Responses to Comments to NMMD Permit Application #GR087EM – Turquoise Mountain Project

Consulting Geologist for Southern Silver Exploration Corp. (US)

The following narratives are in response to Agency Review Comments and requests for additional information regarding the Turquoise Mountain Project NMMD Minimal Impact Permit Application. These comments were electronically received by Southern Silver representatives from the New Mexico Energy, Minerals and Natural Resources Department dated May 26, 2021. A deadline of 30 days was included for a response by Southern Silver to the comments. These comments are being electronically returned to Jennifer Johnson with the New Mexico Mining and Minerals Department (NMMD).

**SOUTHERN SILVER EXPLORATION CORP (US)**  
**TURQUOISE MOUNTAIN PROJECT**  
**Playas Peak 7.5" Quadrangle**

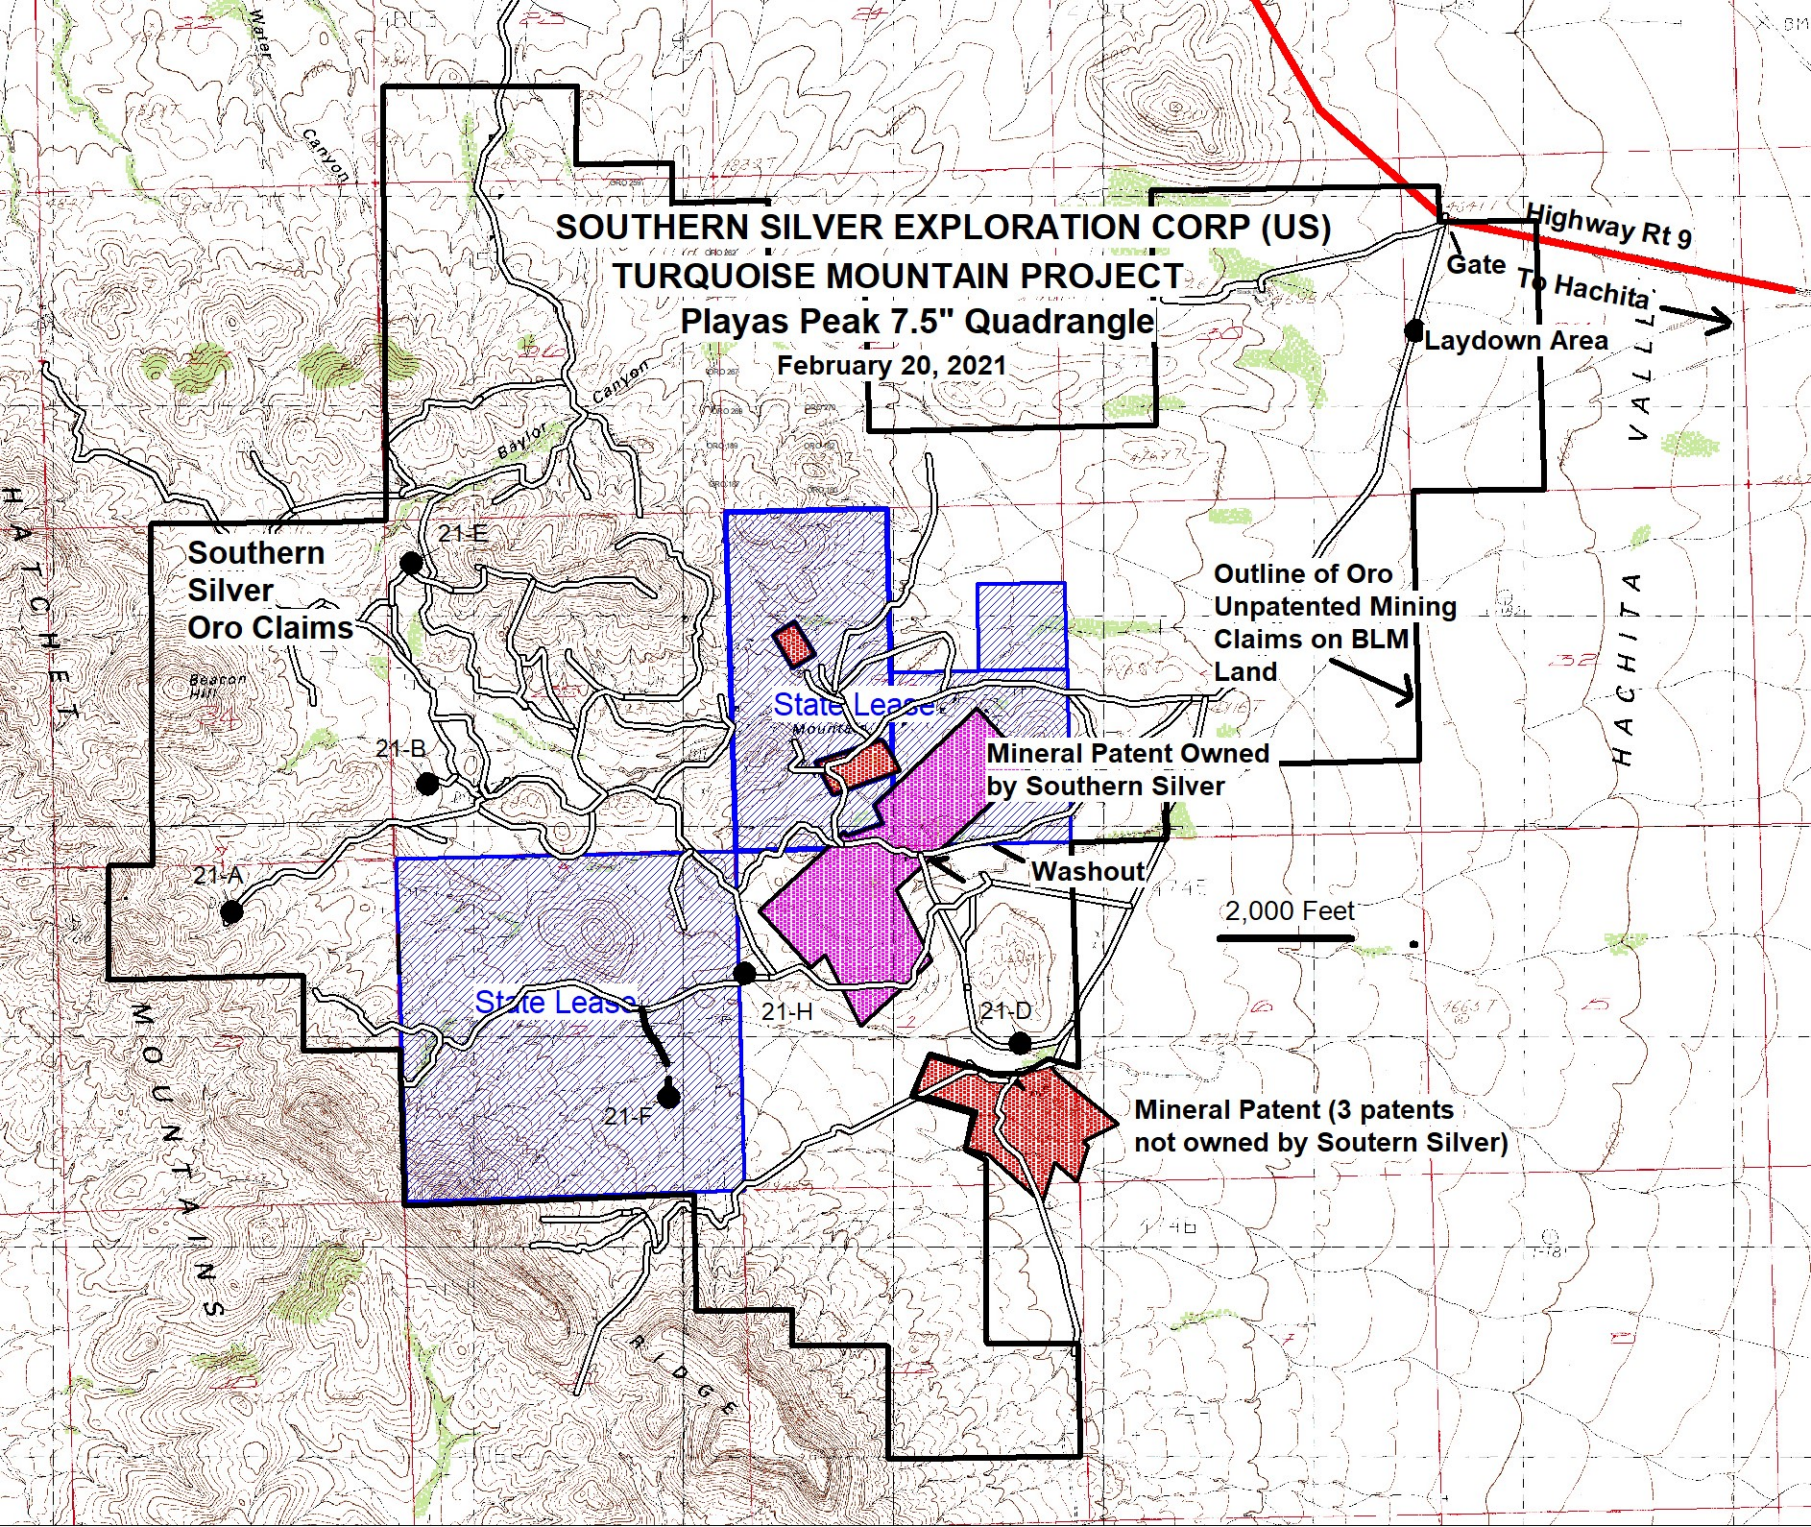
**Comment #1 (NMMD) Request for new map of proposed activities and revised estimate of acreage disturbance:** A map showing the 6 drill sites (reduced from 8 sites originally planned) and a slight change in access to Site 21-F will be submitted to NMMD and the BLM. A list of revised UTM coordinates (NAD83) is also being provided to NMMD and the BLM. These changes of coordinates are minor. A revised bond estimate for the reclamation bond will also be submitted separately to NMMD and the BLM.

Estimates of disturbance are reduced from the originally planned 1.66 acres to 1.35 acres, due to the elimination of two drill sites originally planned that reside in a New Mexico Historic Preservation District. Eighty feet of overland travel was eliminated to Site 21-E due to the relocation of the site to the immediate vicinity of an existing road. One Hundred feet of overland travel to Site 21-A was added to the total area of disturbance. This additional 100 feet of overland travel will occur on a small level ridge within about 150 feet of Site 21-A and avoids a washed out section of the road that would be difficult to repair. Minor changes to the coordinates of the planned drill sites were made, but are less than 30m. These minor changes to the access to Site 21-A and the drill site locations have too little offset to those originally planned to be accurately depicted on the supplied map. The minor changes were discussed with New Mexico State and BLM personnel during the field inspection.
